Re: Plot no: C/7 Jm-3

I have the honour to state that the last amended plan for addition on the above plot was approved by you on 20.7.38 vide your letter no BS.C. 40/3. The entire work could not be completed due to financial circumstances.

PLAN OF PROPOSED ADDITIONS ON
PLOT NO C/1 SHEET JN-3 C.C.H. SOCIETY

Case No. P/C. 593/38

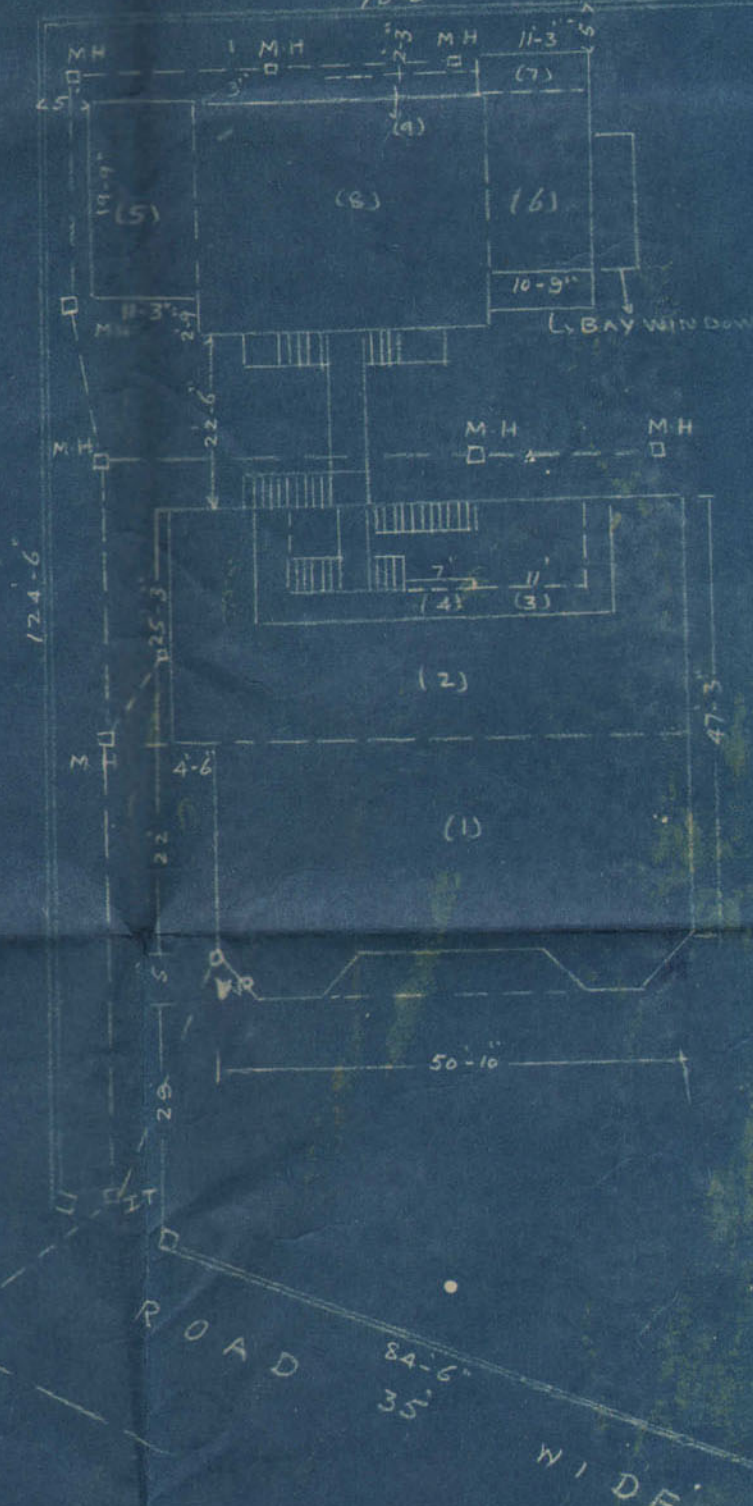
No objection to the plans as
correct

no objection

Position of O.H. tanks should be shown on the plan.

Plot area, side measurements & area of the plot to be correctly shown

This plan with the proposed scheme has already been passed before & the applicant is now has applied for renewal of the permit to which no objection is taken. The area as depicted by CDC is shown as 1190 which accords to our calculation. Cons to 1216.8 sq. yds which is 18/11

As such the shall be no objection in approving the plan as now submitted. 17/2/38
